ADDENDUM NUMBER TWO

System Operations Center
Henderson Water Utility
Henderson, Kentucky

(Solicitation Number: 2022-01)

1 Typical Perimeter Stem Wall
 1/S5.1 3/4" = 1'-0"

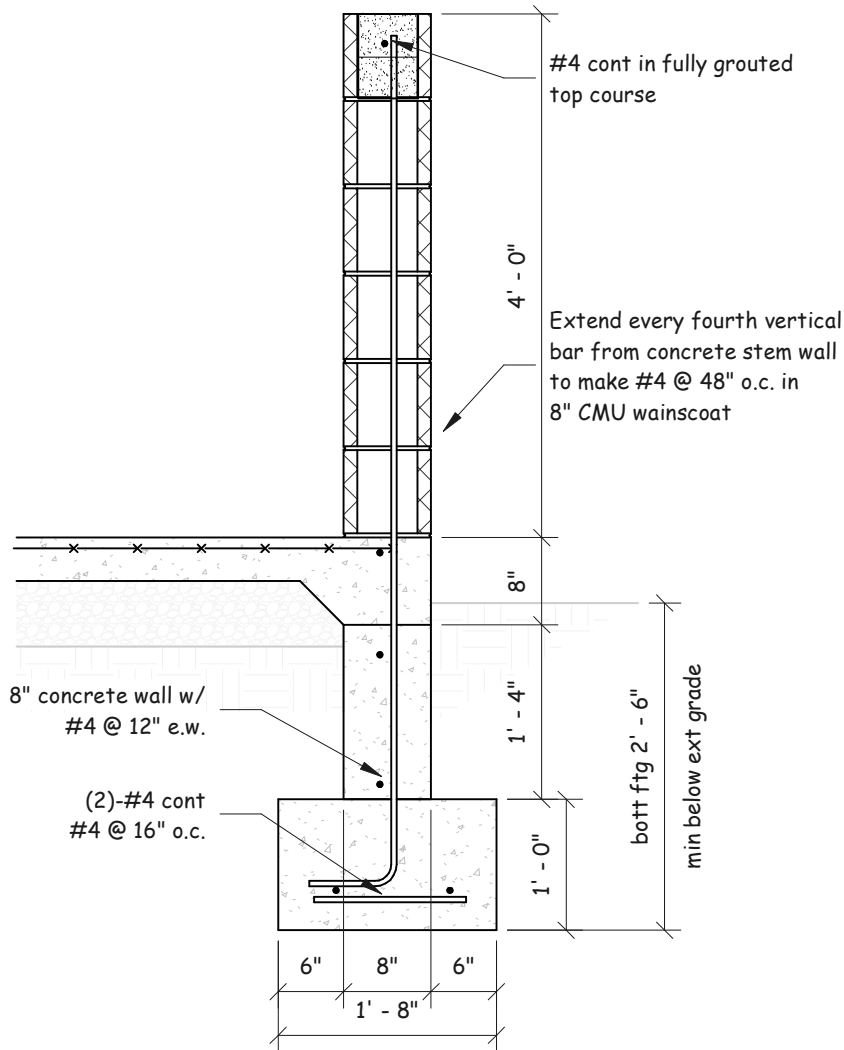
A. Detail 1/5.1 – Typical Perimeter Stem Wall

- To be changed to include a 4’-0” high CMU wainscot wall as detailed on the attached sheet. CMU wainscot to be around the entire perimeter, stack bond, and painted. No brick units are required.
